RESPONSES TO
NRC QUESTIONS
ON THE
MONTICELLO PUAR

PREPARED BY
NUTECH ENGINEERS, INC.
SAN JOSE, CALIFORNIA

PREPARED FOR
NORTHERN STATES POWER CO.

NRC QUESTION ON MONTICELLO PUAR
HYDRODYNAMIC LOAD RESPONSE

Figure 4 - 2" ϕ

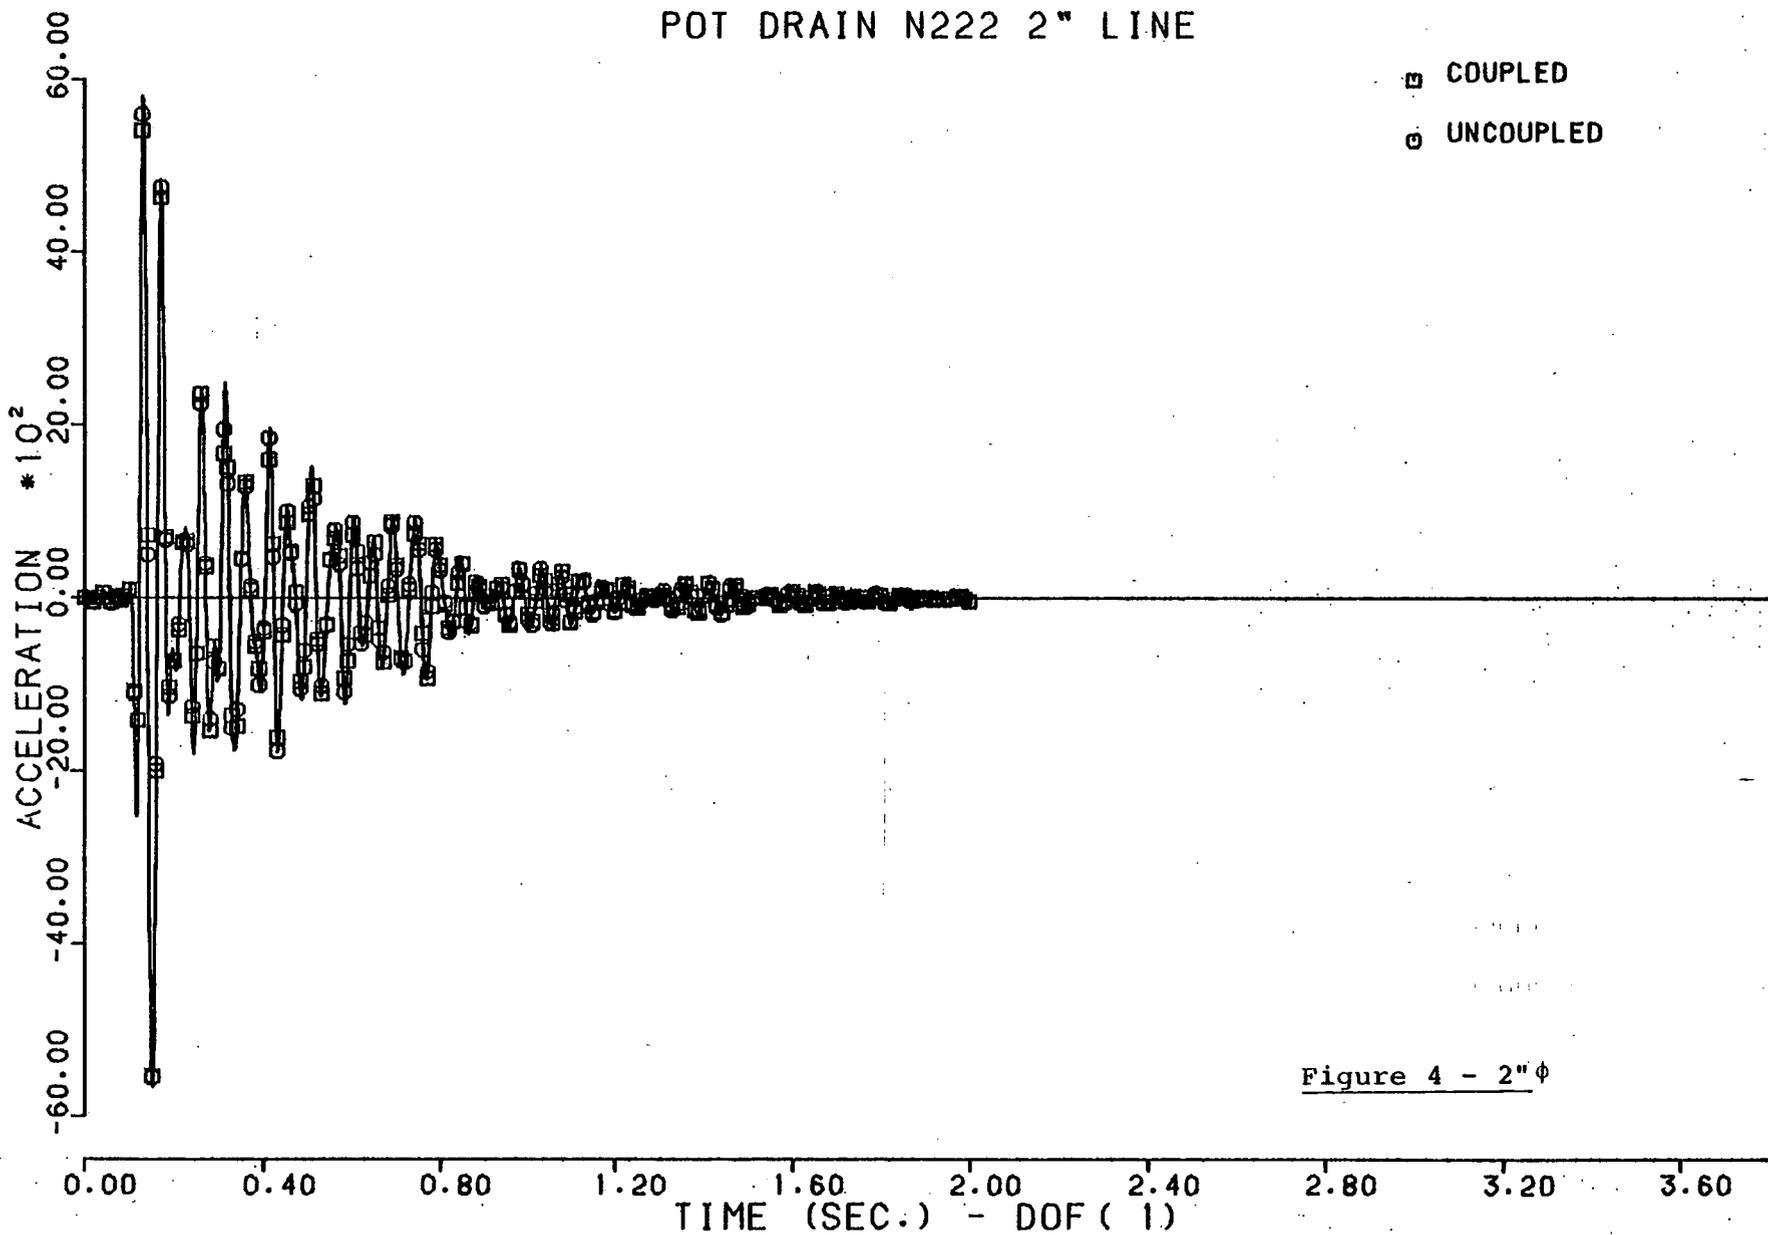
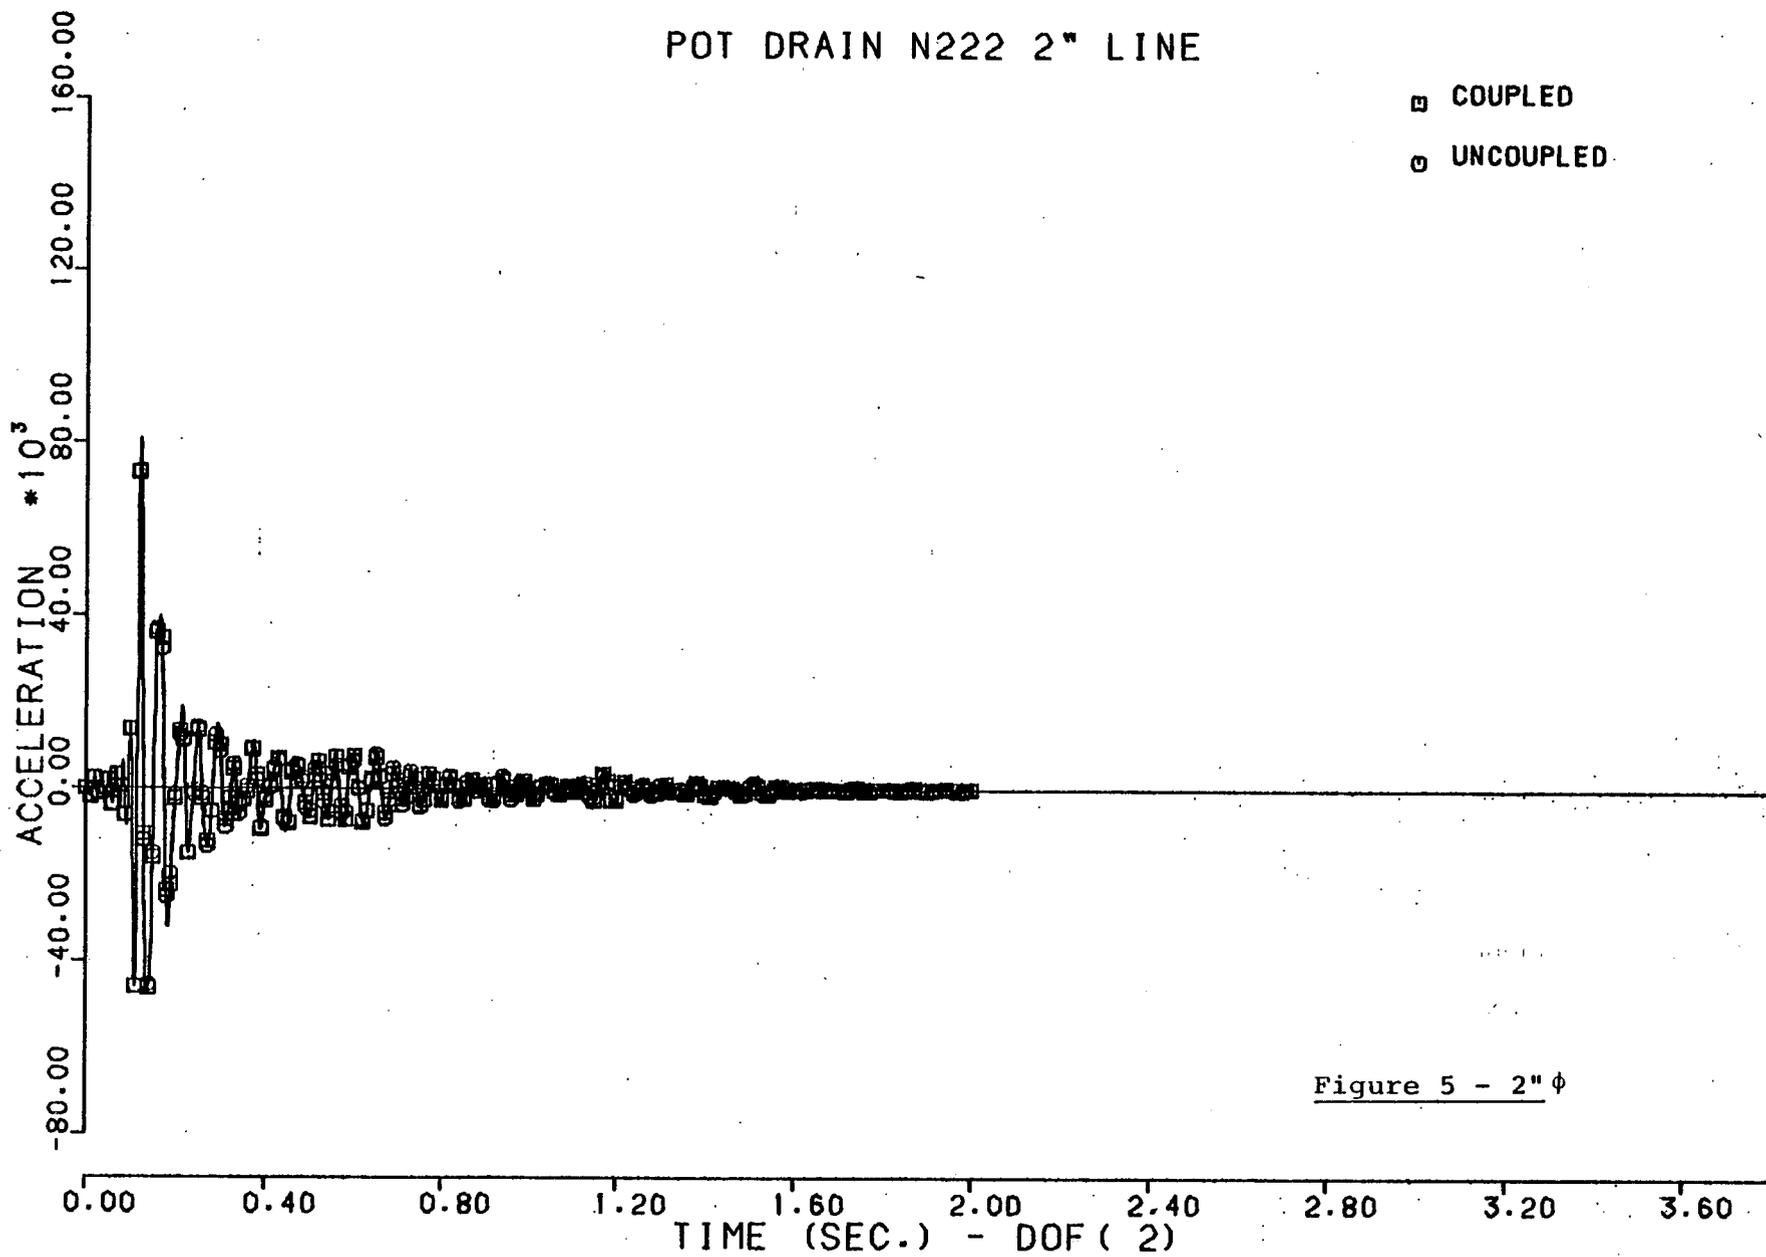
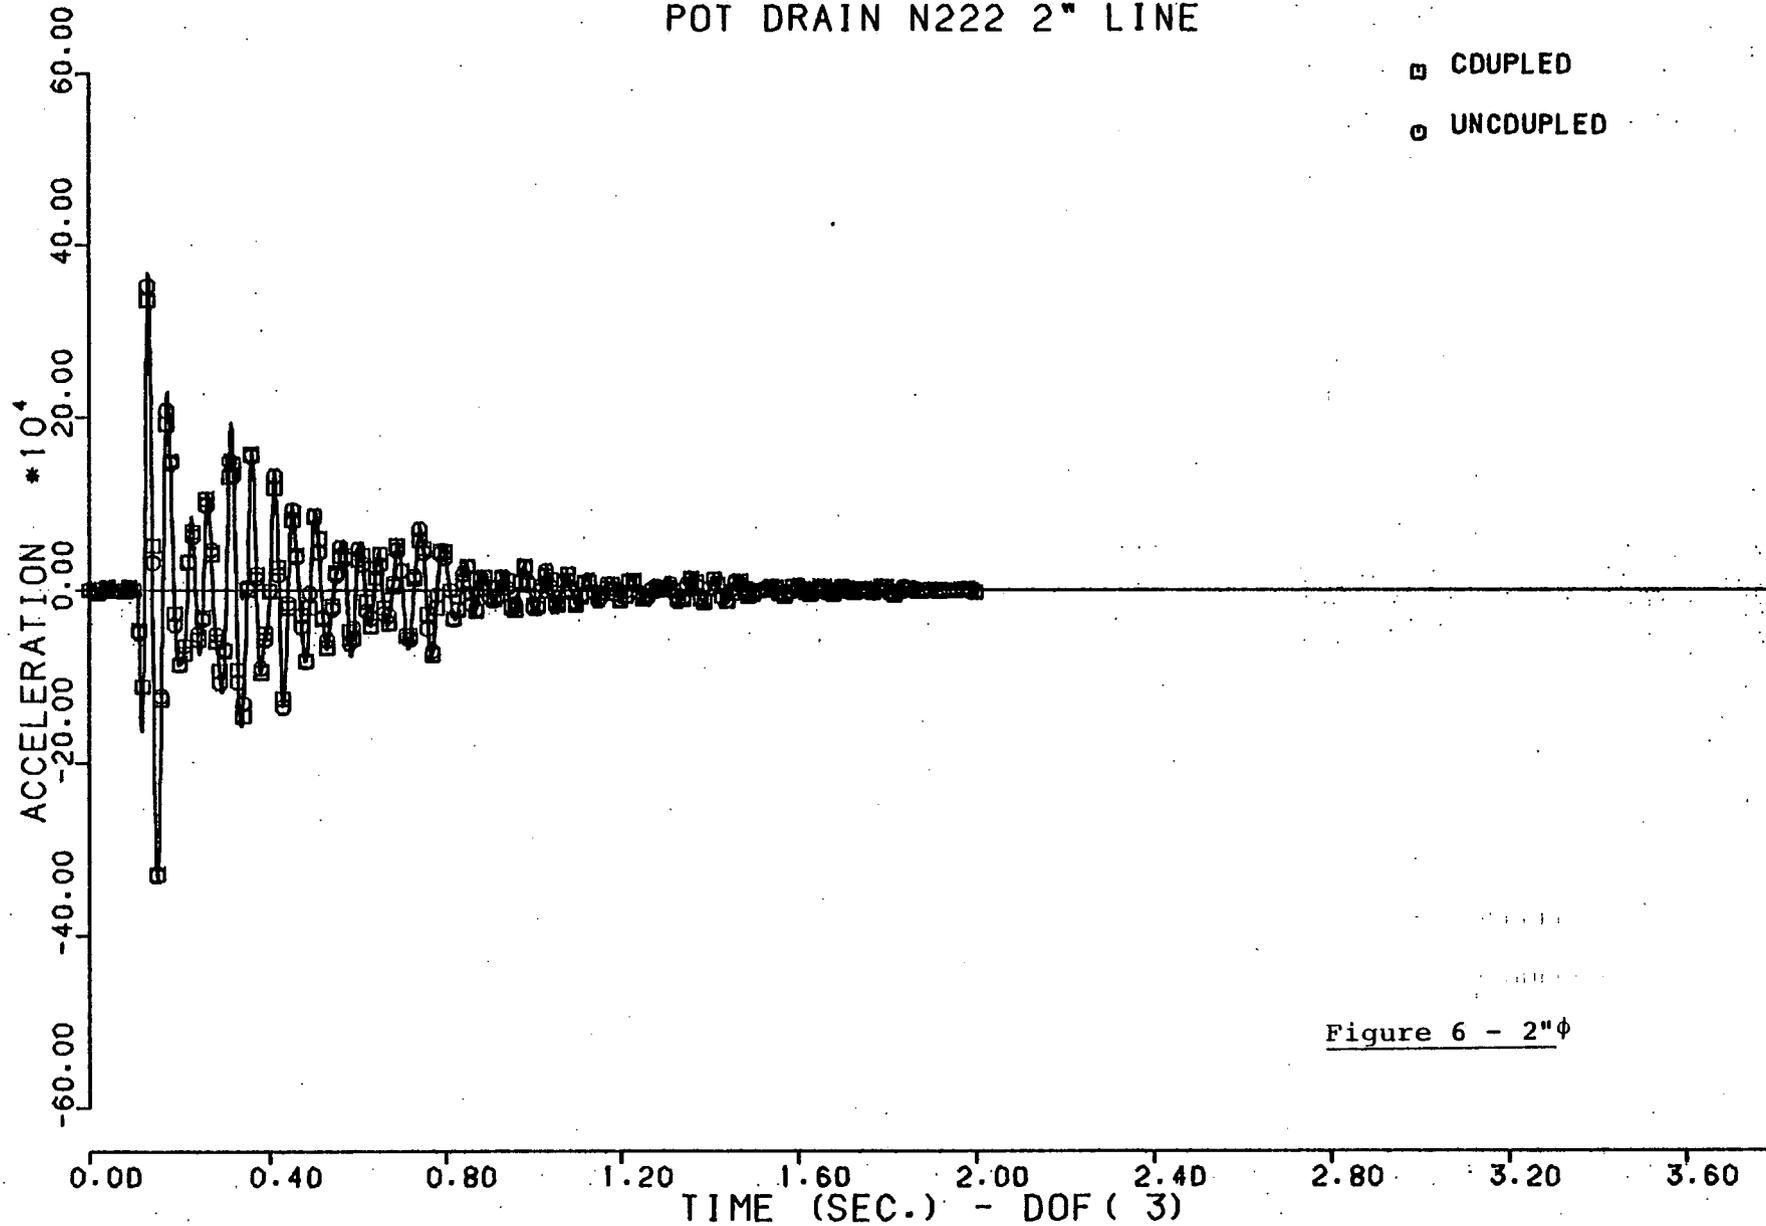
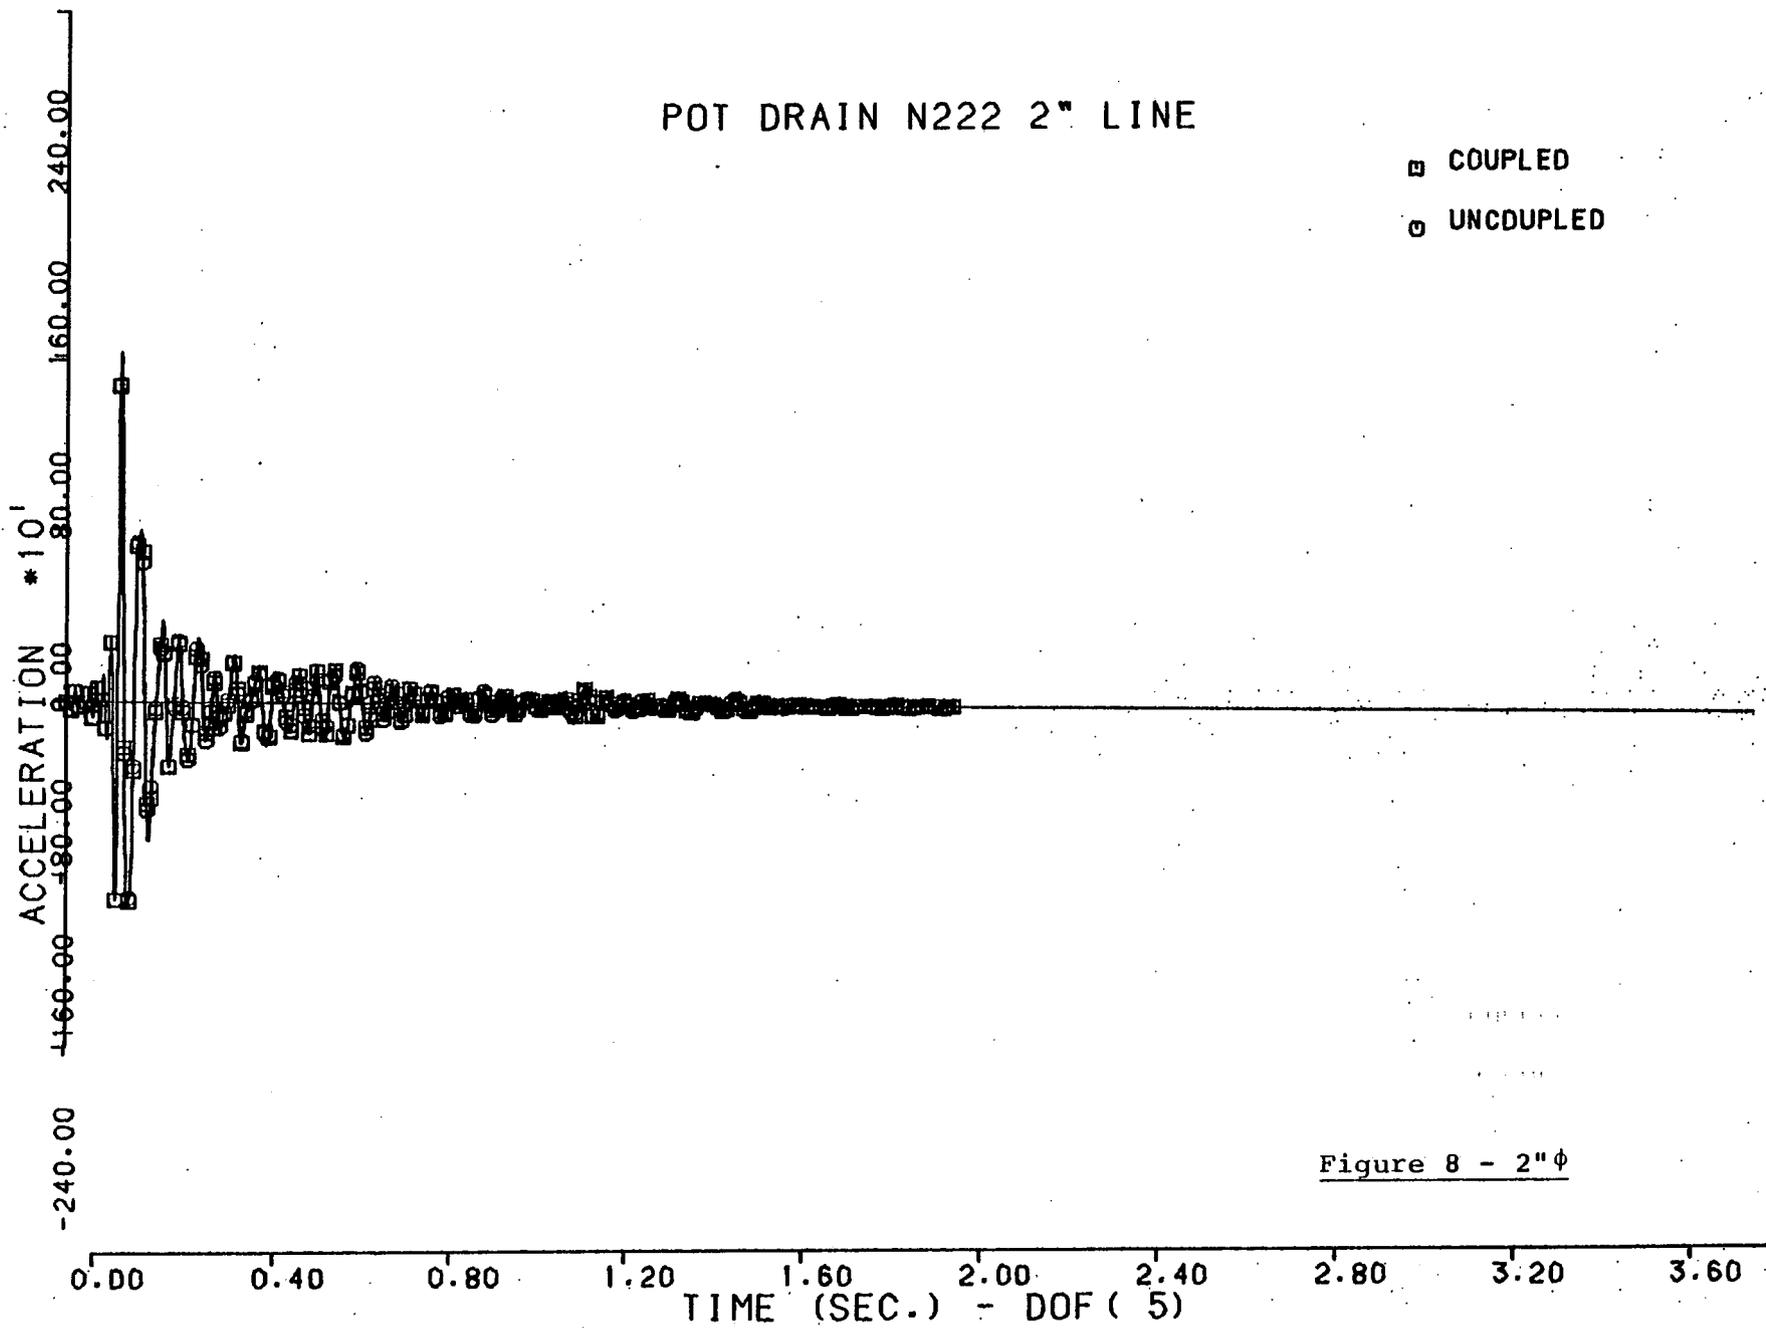
ITEM 12: The computer code CMDOF has been used in the torus attached piping analysis for all plants that utilized NUTECH as their contractor. With regard to the code provide the following information:

- 1) Theoretical background of CMDOF computer program
- 2) Program verification
- 3) Applicability of the computer program to the torus attached piping analysis.

To illustrate the effect of pipe size on coupling, four typical piping systems were examined and the coupled and uncoupled time histories plotted together. These time histories include both the smallest (2") and larger (20") systems analyzed. Listed below are the figure numbers and the corresponding line size.

Figure 4-8	2" diameter
9-13	4" diameter
14-18	6" diameter
19-21	20" diameter

These plots confirm the expected variation of coupling benefit with pipe size.
